Product Support Bulletin 2009-016

Maintenance of Way ~ Work Equipment Bulletin

SUBJECT: Propel Pedal Guard Kit – 98760061

MACHINE MODEL(S): TRIPP Tie Exchanger

Figure 1

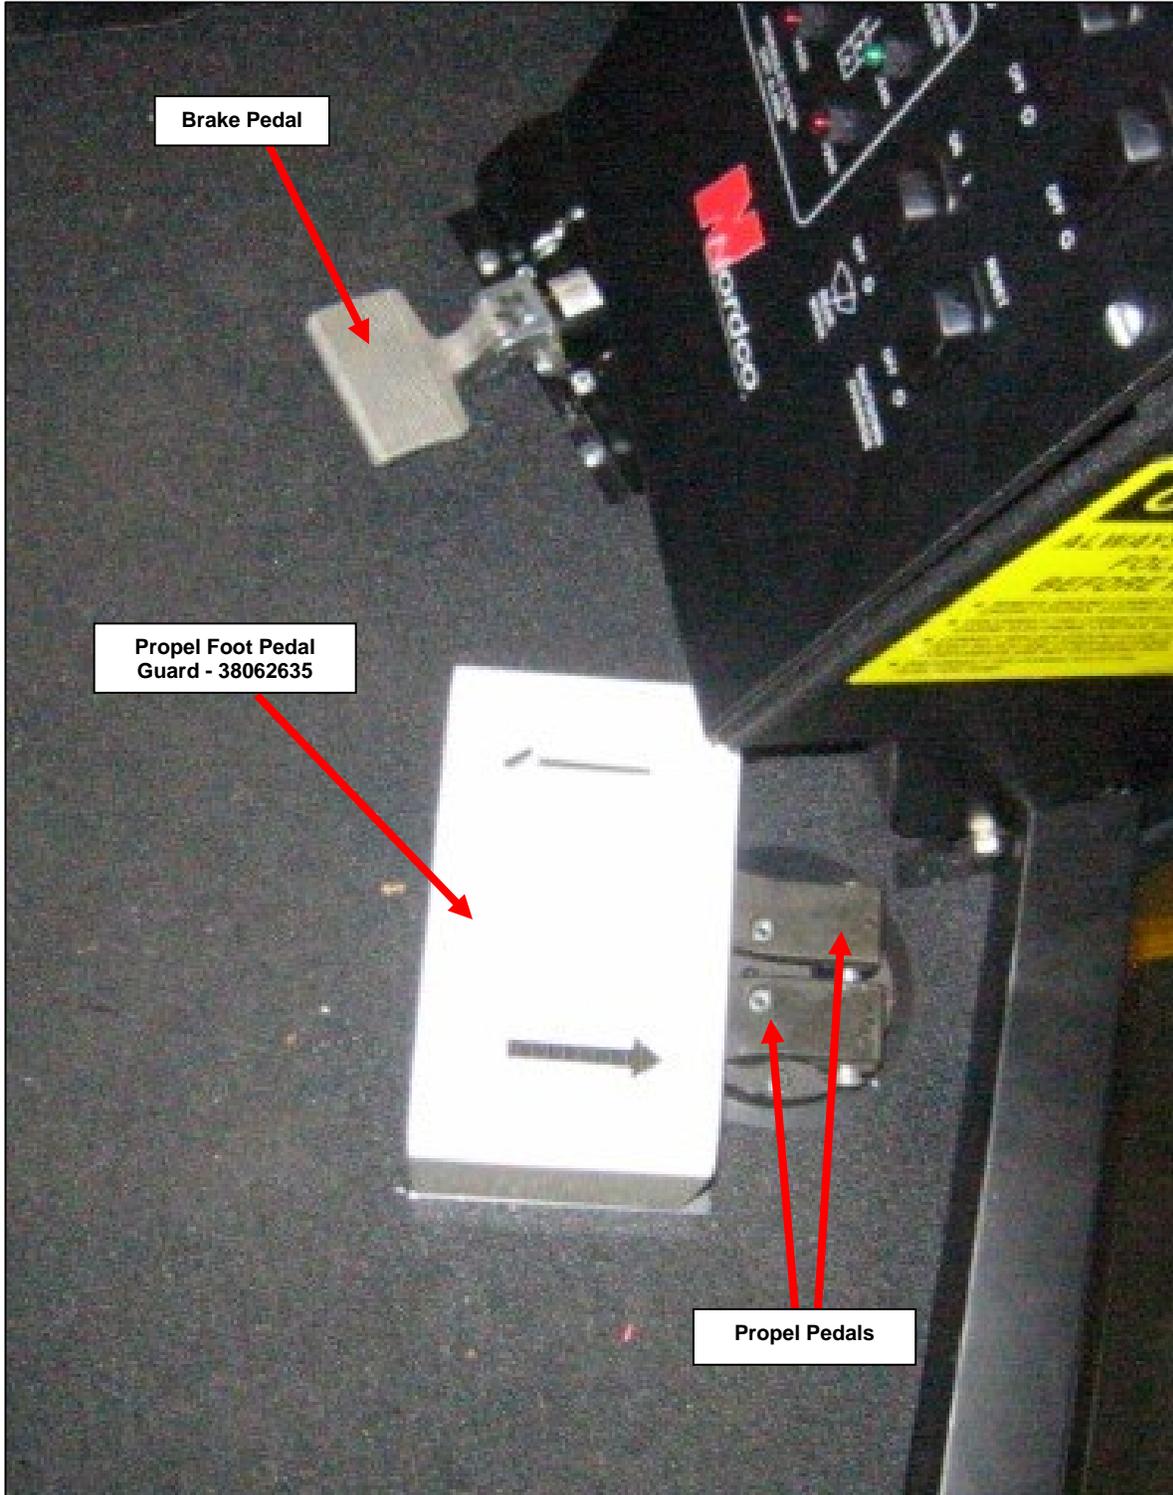
OPERATIONAL IMPACT: Installing this kit will prevent the operator from accidentally stepping on the Propel Foot Pedals. The top of the Guard has arrows cut into it to indicate the travel direction of each foot pedal. The Guard does not cover the Brake Pedal. See Figure 1 on Page 2.

ACTION: This kit is easily installed in the cab of any of the TRIPP machines listed above. Installation consists of cutting 2 slots in the rubber floor mat and drilling 4 holes in the cab floor to mount the guard. See Figure 2 on Page 3.
